## RESPONSE TO REQUEST FOR ADDITIONAL INFORMATION

### APR1400 Design Certification

RAI No.: 264-8243  
SRP Section: 06.02.05 – Combustible Gas Control in Containment  
Application Section:  
Date of RAI Issue: 10/22/2015

### **Question No. 06.02.05-6**

**Figure 1 Schematic Diagram for ECSBS Check Valve**

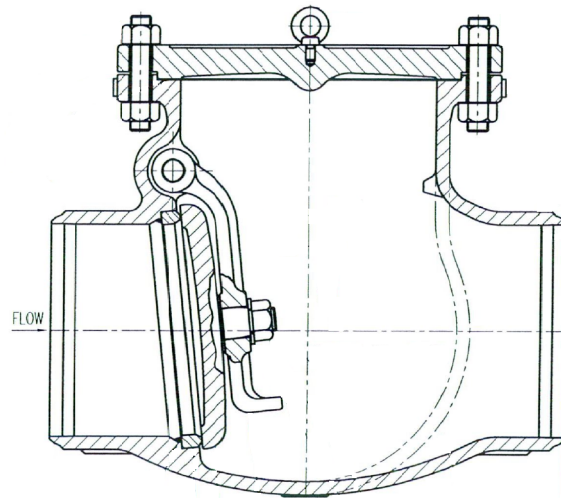
In the equipment survivability analysis described in DCD Tier 2, Section 19.2.3, credit is taken for maintaining the containment pressure below the factored load category of 123 psia, per DCD Tier 2, Section 19.2.4.2.3, by relying on the emergency containment spray backup system (ECSBS). See DCD Tier 2, Figure 19.1-3, Simplified Diagram – Containment Spray System. This is a single train system, with its own dedicated ECSBS spray ring header and an inside containment isolation check valve, V1014. This backup spray function is the basis provided for limiting the equipment survivability analysis to 24 hrs, as stated in DCD Tier 2, Section 19.2.3.3.7.2, "Determination of Severe Accident Environmental Conditions." This valve should

be shown to meet the equipment survivability conditions, including surviving a hydrogen burn and remaining open. This valve should be added to DCD Tier 2, Table 19.2.3-4.

The purpose of the Equipment Survivability (ES) assessment is to show that there is reasonable assurance that the equipment and instrumentation used to mitigate and monitor severe accident progression will perform their intended functions (such as, hydrogen mitigation, containment monitoring, reactor cavity flooding, etc.) under the harsh environmental conditions of severe accidents. Check valve V1014 for ECSBS has a containment isolation function during normal operation and design basis accidents. In the severe accidents, the containment isolation function can be maintained by the ECSBS containment isolation valve (V1013) which is installed outside of containment, as shown in DCD Tier 2, Figure 6.2.2-1.

The check valve has another function of water delivery to the ECSBS header during severe accidents. However, the ES evaluation of the check valve is the same as piping due to its water delivery function to the ECSBS header, for the following reasons:

- The check valve resists damage due to temperature increases because the check valve consists of only metallic parts; the valve contains no organic materials. The metallic parts resist thermal damage which result from the hydrogen burn or the continuous temperature rise which results from decay heat.
- It is expected that the check valve continues to function due to its simple structure, as shown in Figure 1.

Therefore, it is not necessary to additionally evaluate the survivability of check valve V1014, and it is not required to be added to Table 19.2.3-4.

Figure 19.1-3 Simplified Diagram - Containment Spray System

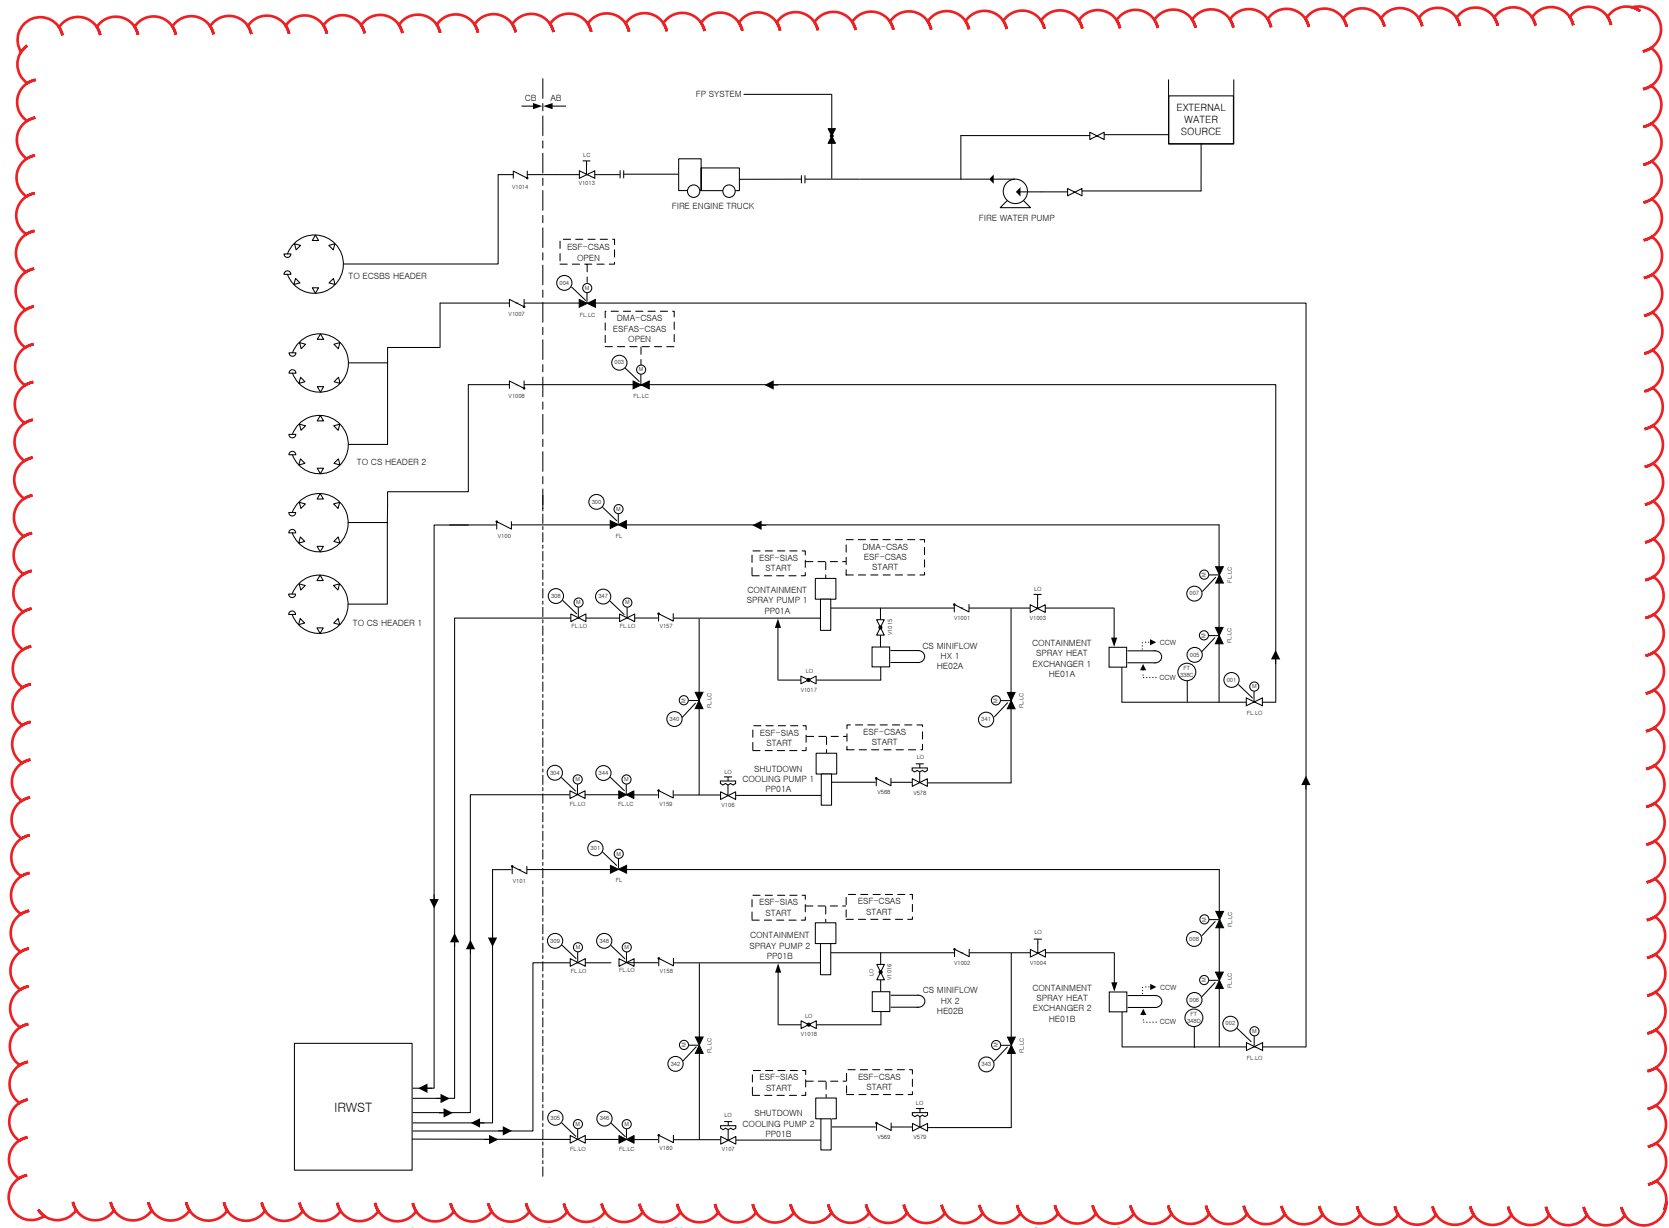
Please confirm that all of the check valves shown in DCD Figure 19.1-3, Simplified Diagram – Containment Spray System, are depicted correctly to indicate the direction of flow. Check valves V1014, V1008, and V1007 appear to be shown in an inconsistent direction as compared to V101 and V100. Adding flow direction arrows below the check valve symbol, as done in DCD Tier 2, Table 6.2.4-1, would provide clarification.

As part of your response, please revise all the affected DCD text, tables, and figures accordingly.

DCD Tier 2, Figure 19.1-3 will be revised to correct the directions of flow for check valves (V100, V101, V1007, V1008 and V1014), as shown in Attachment 2 to this response.
